WOLF CREEK

August 23, 2006
ET 06-0034

Subject: Docket 50-482: Wolf Creek Nuclear Operating Corporation's
Response to Request for Additional Information Regarding 10 CFR
50.55a Requests I2R-37 and I2R-38

**Response to Request for Additional Information (RAI) Regarding 10 CFR 50.55a (Relief)
Requests I2R-37 and I2R-38**

Figure 1

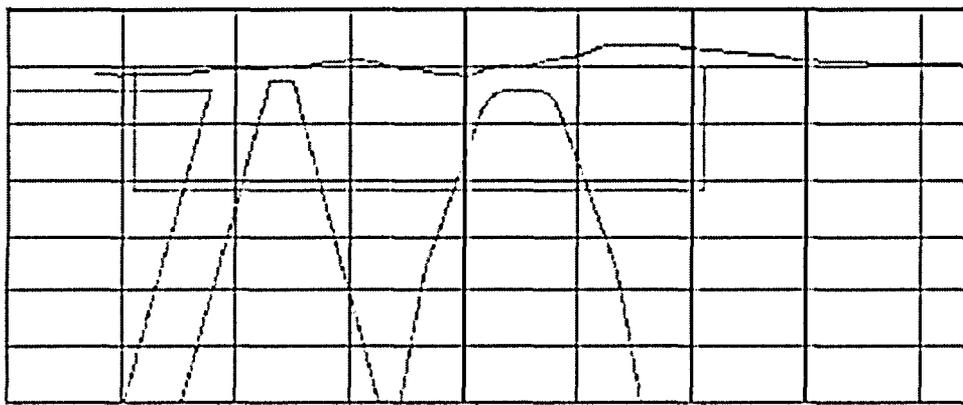
- (2) Describe the extent and locations of the observed surface irregularities and provide explanation with the assistance of sketches to show that the observed surface irregularities will only affect the detection of axial flaws. Also, discuss what measures you have taken to ensure that the surface condition of the weldment will provide a reliable eddy current examination.

The surface irregularities are located around the inside diameter of the subject welds and are the result of counterbore tapers and/or grinding of the root pass. These surface irregularities do not meet the criteria for smoothness as stated on the Performance Demonstration Qualification Summary (PDQS) for the procedure.

Examination of these welds was performed using a qualified and demonstrated procedure, PDI-ISI-254-SE. During the qualification of this procedure, the detection of axial flaws was limited due to severe irregularities in the inside diameter (ID) contact surfaces of the Performance Demonstration Initiative (PDI) test set. The detection of circumferential flaws met the Appendix VIII criteria on these surfaces with severe irregularities during the PDI performance demonstration. The attached figures 1 and 2 illustrate examples of mapped ID surface irregularities that limited the detection of axial flaws during the qualification of the vendor's procedure, but did not limit the detection of circumferential flaws.

Figure 3
Inlet piping to safe-end and safe-end to inlet nozzle welds

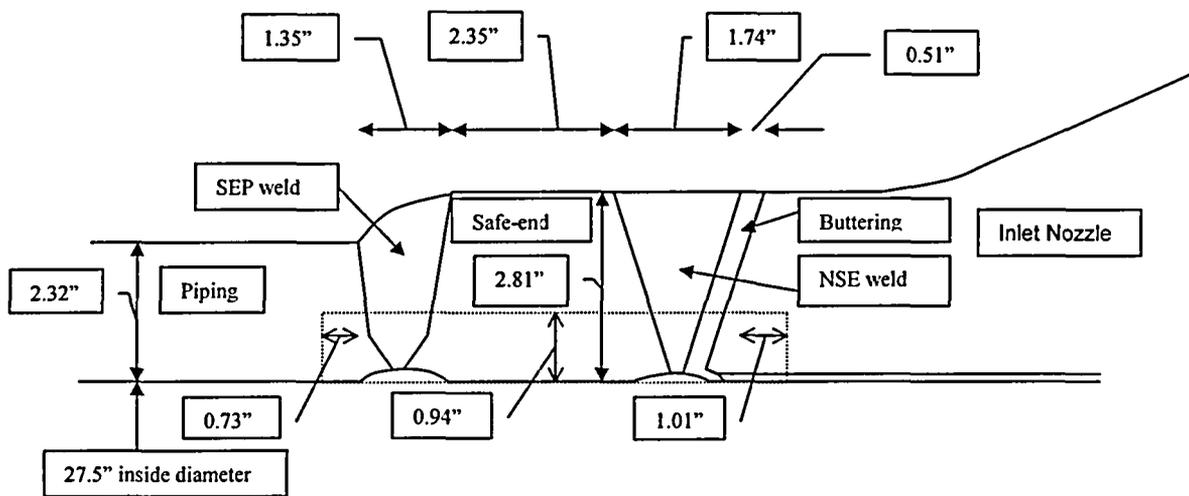
(3) For each listed safe-end component, provide the information with a sketch regarding the dimensions of the components and welds, materials, component names and the dimensions of the code required inspection volume.

See attached Figures 3 and 4 for dimensions and the table below for the component and weld material.

Per Figure IWB-2500-8(c) of ASME Section XI, the volume required to be examined is the inside surface extending up to 1/3 of the thickness of the piping and extending out to 1/4" past the edge of the weld crown on each side of the weld. The volume that was actually examined is shown by the dotted line box in the Figures 3 and 4. The figures show that the examined volume extends well beyond that required by the Code. This additional volume was added by the vendor as a "conservative scan factor".

BB-02-FW301; 6" 180 degree return (SA-312 TP304) to 6" flange (SA-312 TP304) with weld filler material of 308.

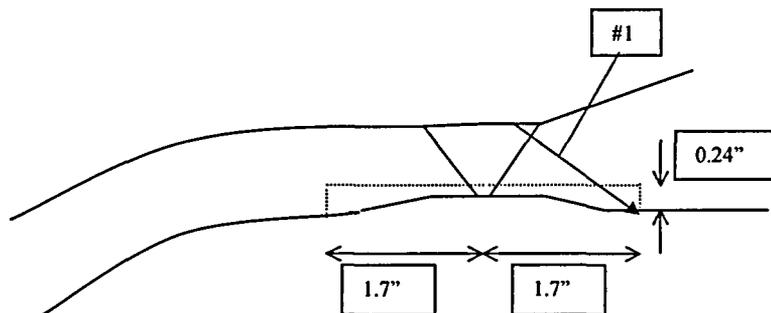
(2) Provide the following information for each listed piping weld with the assistance of a sketch:
 (i) materials, names and dimensions of components and welds, and
 (ii) dimensions of the Code required area of examination coverage and the actual area of coverage based on the best effort examination.

Joint size: 6" sch. 160, nominal OD 6.625", nominal thickness 0.719"; counterbore ID 5.325"

This examination area extends to 0.25" beyond the counterbore as required. The amount of axial coverage obtained by the best effort examination, utilizing the supplemental 60 degree longitudinal wave search unit, is 85.2% of the area on the far side of the weld. Arrow #1 in the diagram above depicts the extent of the best effort examination perpendicular to the weld. The best effort parallel scan was conducted to the extent possible from the weld crown. This scan examined 32.4% of the area on the far side of this weld.
